Planning Commission

Agenda Item #7a O'Reilly Auto Parts Site Plan Review Request

Webb Architects, representing O'Reilly Auto Parts of Springfield, Mo, is requesting site plan approval for their new store proposed for 369 Blue Star Highway. City departments have reviewed the plans and have offered comments as has the zoning administrator. Those comments are included in this agenda and have been forwarded to the applicant. The applicant is working on addressing the comments and will be prepared to discuss those items at the meeting.

PROJECT:
 NEW O'REILLY AUTO PARTS STORE
 BLUE STAR HIGHWAY
 SOUTH HAVEN, MICHIGAN

1 LANDSCAPE PLAN
 L1 SCALE: 1" = 20'

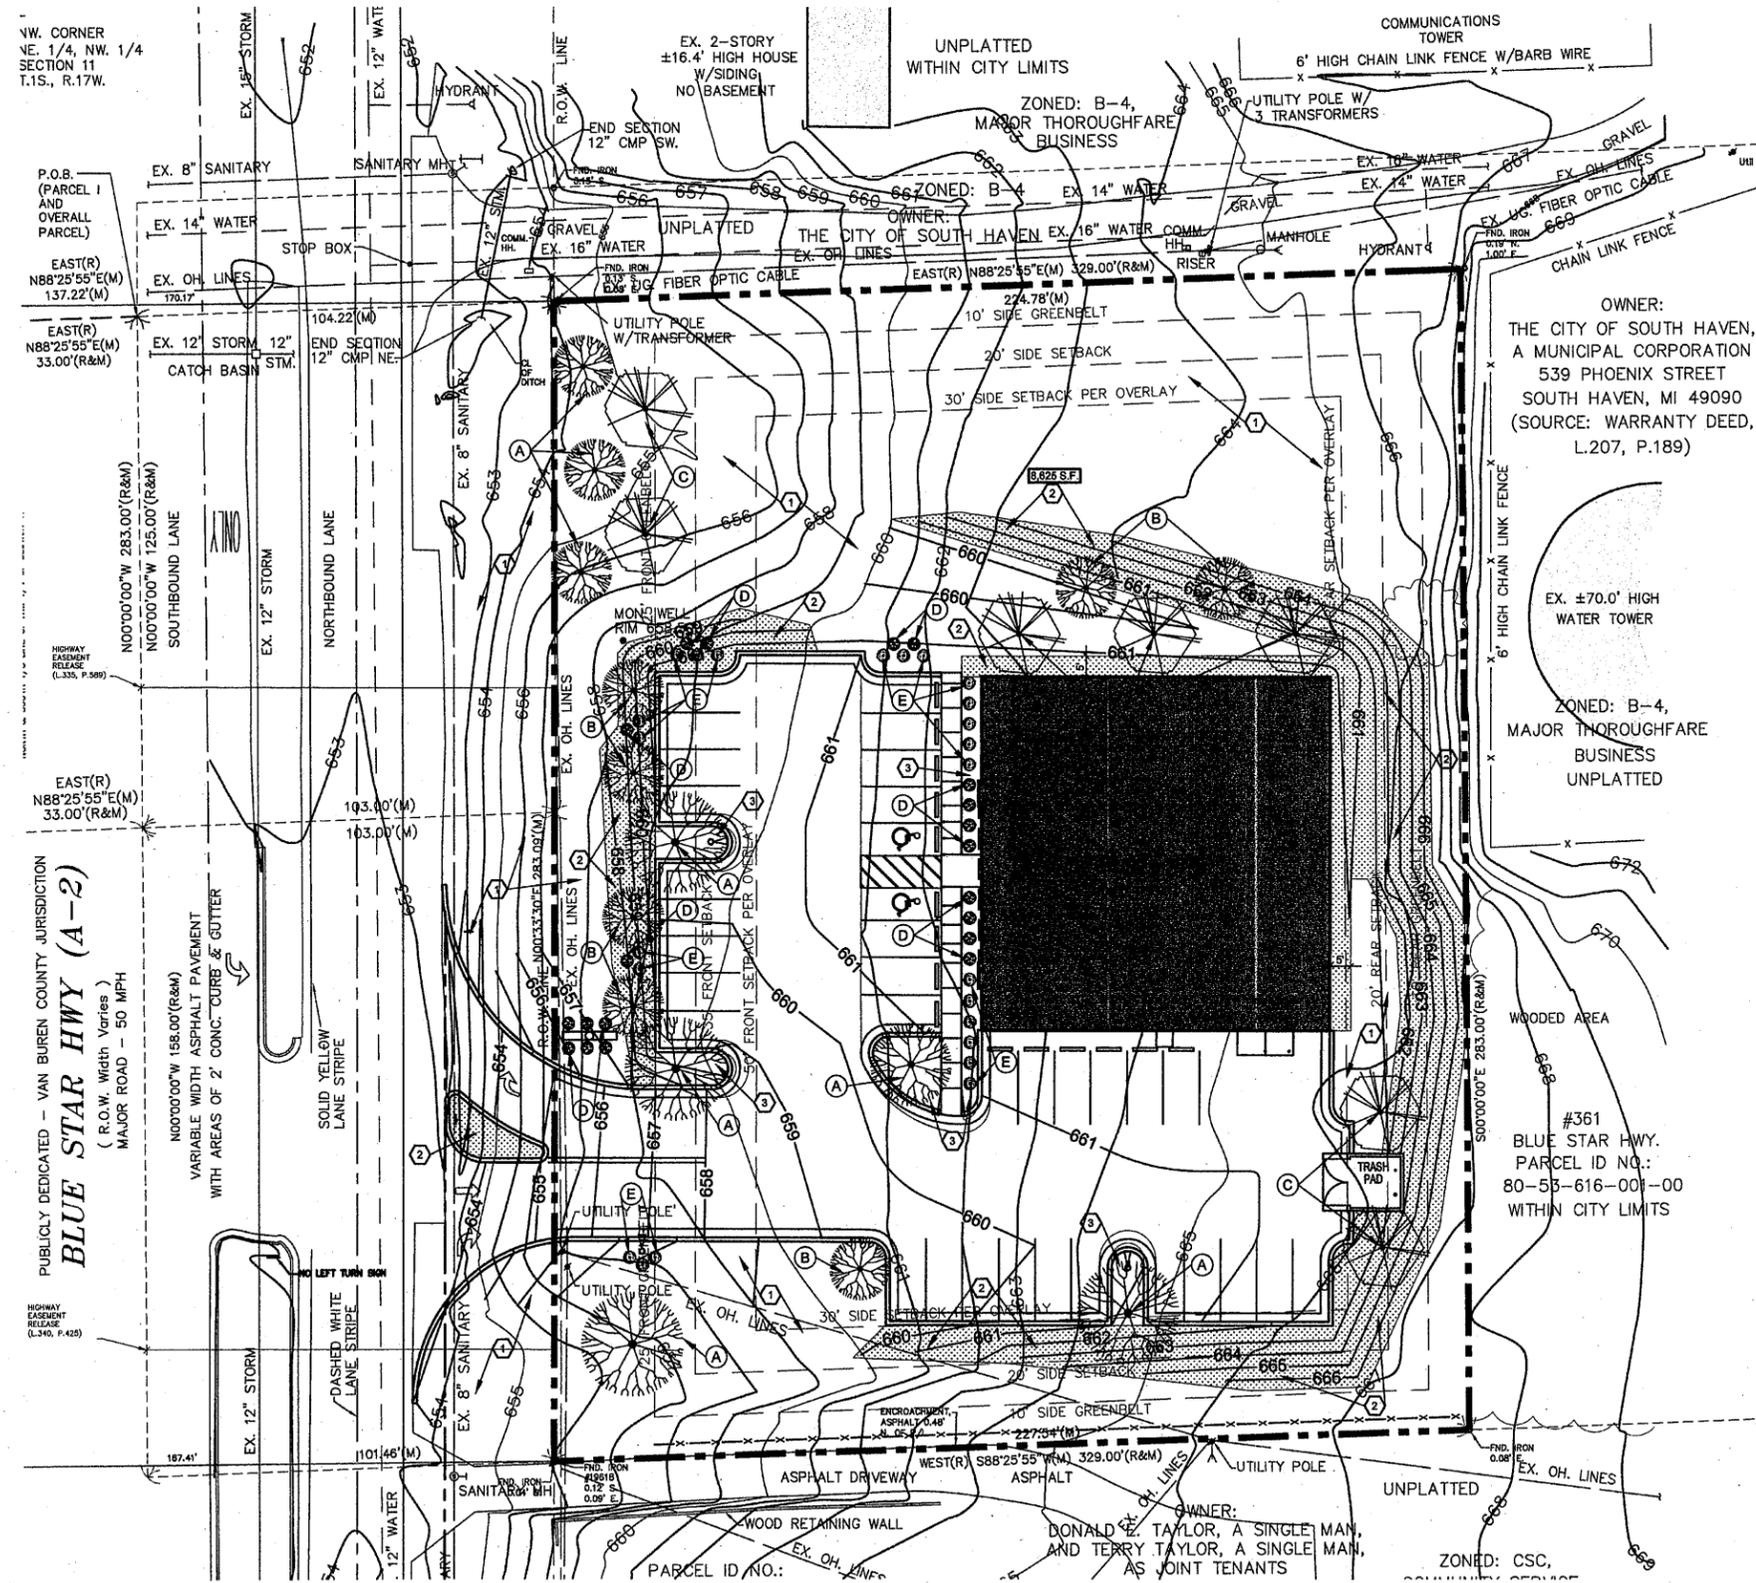
8. Sheet L1 appears to show a paved area along the outer perimeter of the parking lot and within the greenbelt area along the front of the site. The actually parking lot does not

show as paved except on Sheet C2. The applicant needs to clarify whether these assumptions are correct and explain the rationale and/or correct the sheet key.
